ADDENDUM NUMBER ONE
23rd STREET PUMP STATION ELEVATOR UPGRADE
CONTRACT NO. W-19-025-201
CITY OF CHATTANOOGA, TENNESSEE

The following changes shall be made to the Contract Documents, Specifications, and Drawings:

KONE EcoSpace™

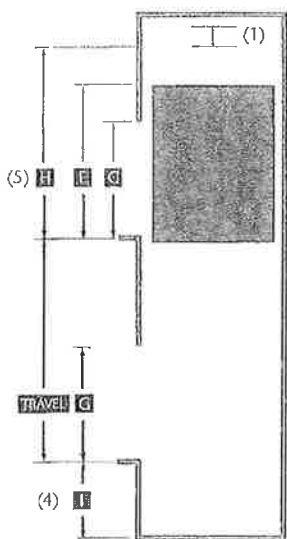
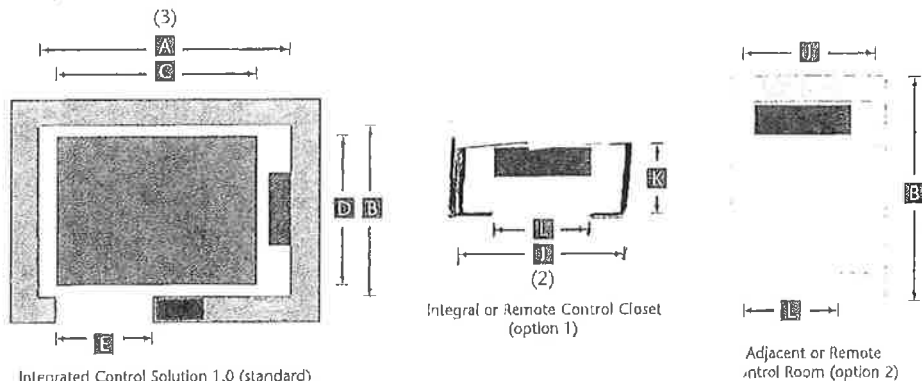
4. The new controller cabinet must be lockable and must be located in a control space for the controller and disconnects. The control space shall be manufactured by Kone, or an approved equal. The requirements shall be a Kone MRL type elevators, or an approved equal. The control space must have the disconnects located with the controller. If the contractor needs more width, how much more would be determined by the width of the disconnects and how far they would be located from the controller. It would be the responsibility of the contractor to obtain all measurements and provide any stamped electrical or mechanical drawings required to obtain all electrical and mechanical permits. See attached drawing of a KONE EcoSpace Configuration and Dimension drawing.

The contractor shall be responsible for determining the allowable space from the disconnects to the controller. The controller shall be 36"(W) X13"(D). The control space shall go on the wall to the right if you are facing the elevator.
